WARRANTY BULLETIN

Campaign no.: 2015-0003

Subject: **Knock Sensor Harness Incorrectly Routed.**

YEAR	MODELS	SERIAL NUMBER
2015	Spyder F3	See warranty campaigns to verify in unit history

rbg2015-004-002_a

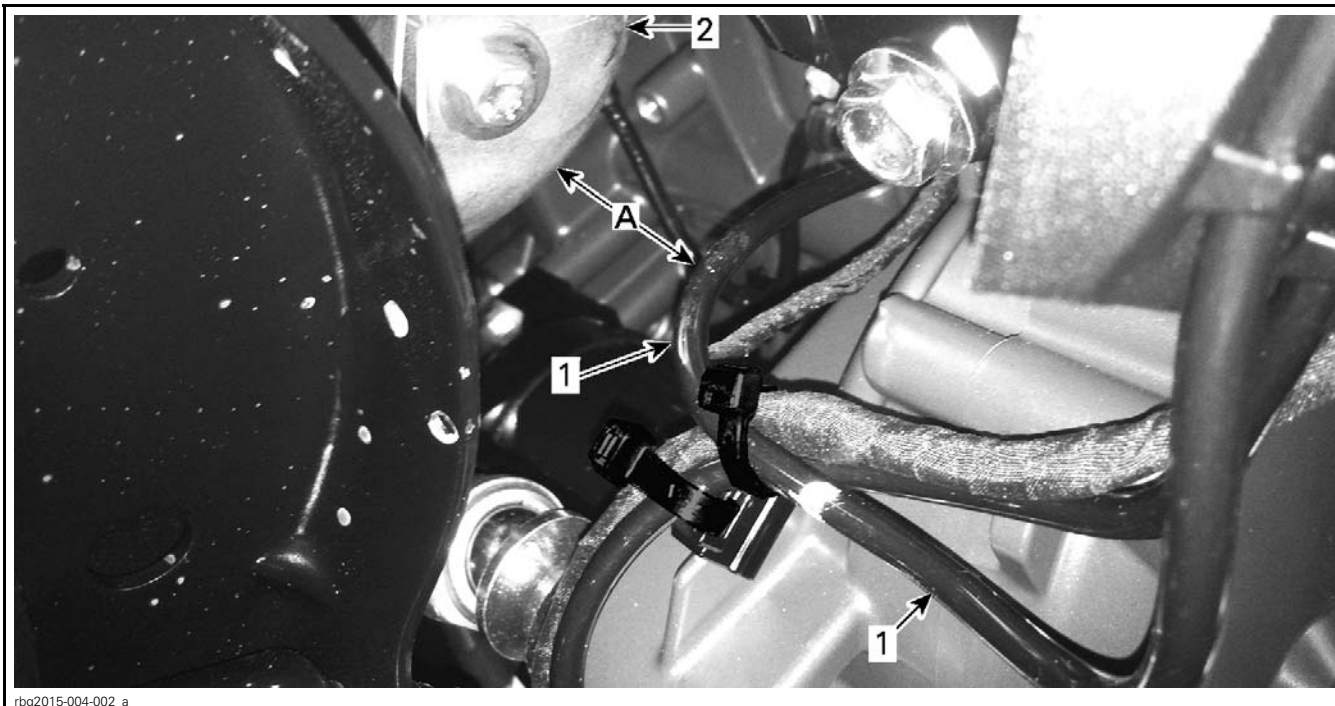
The knock sensor harness may melt if routed too close of the exhaust manifold heat shield. A melted harness would lead to a limp home mode.

LOCATION - FRONT LH SIDE OF ENGINE

- 1. Knock sensor harness
- 2. Exhaust manifold heat shield
- A. Distance between harness and heat shield

Reroute the sensor harness further away from the heat shield if not as specified.

DISTANCE BETWEEN HARNESS AND HEAT SHIELD		
Distance "A"	Greater or equal to 30 mm (1-3/16 in)	ok
	Less than 30 mm (1-3/16 in)	Repair

rbg2015-004-002_b

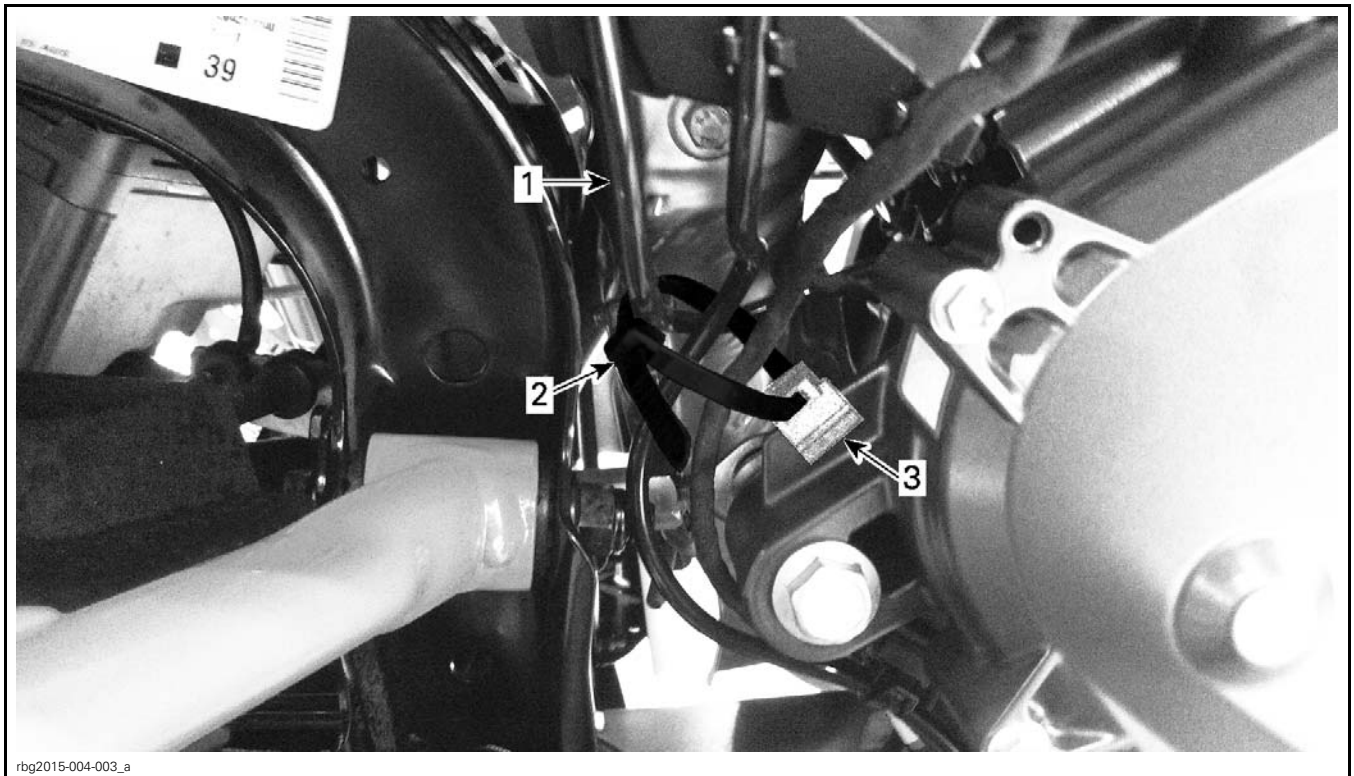
Repair Procedure

- 1. Knock sensor harness
- 2. New locking tie - loose
- 3. Locking tie clamp

Step 1: Adjust harness length (take up slack) and tighten locking tie
 Step 2: Cut excess flush with locking tie head

NOTICE Do not over tighten the locking tie

rbg2015-004-005_a

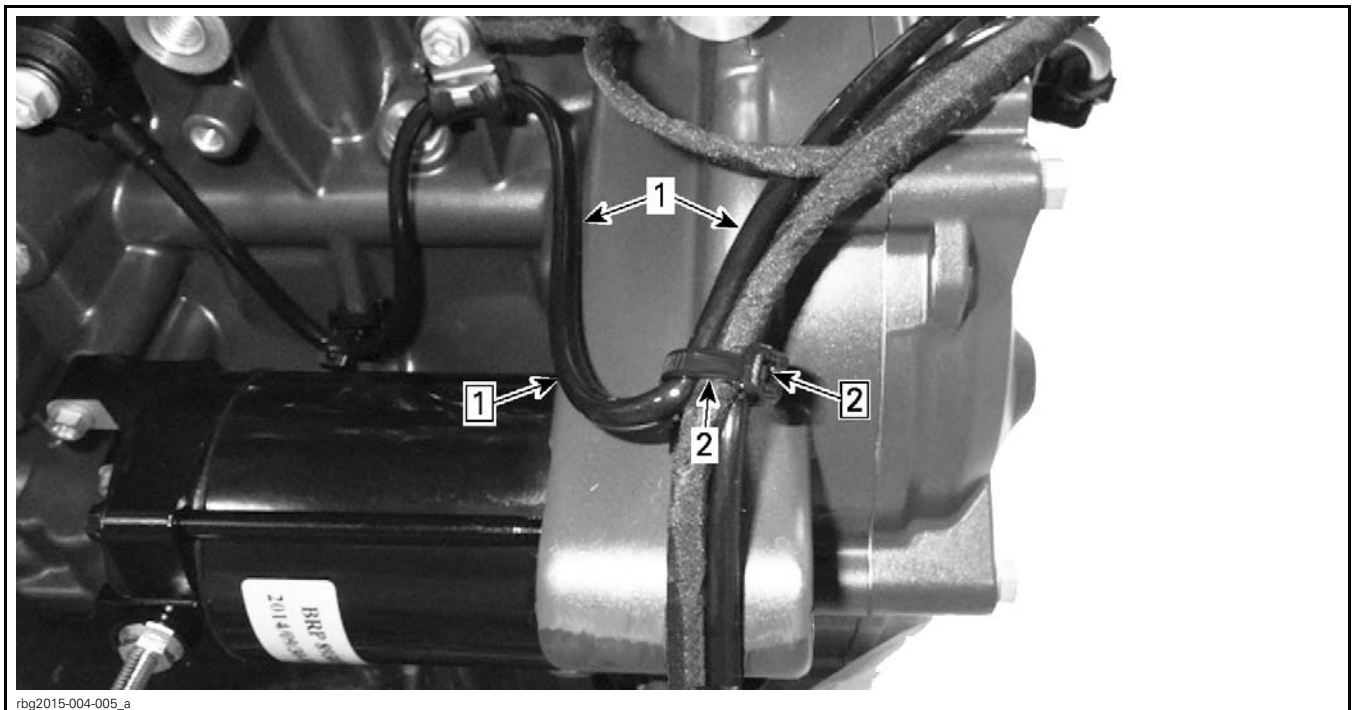
FRONT VIEW - ENGINE OUT OF VEHICLE FOR CLARITY

- 1. Knock sensor harness
- 2. New locking tie

Check distance between harness and heat shield. Refer to table in *INSPECTION PROCEDURE*.
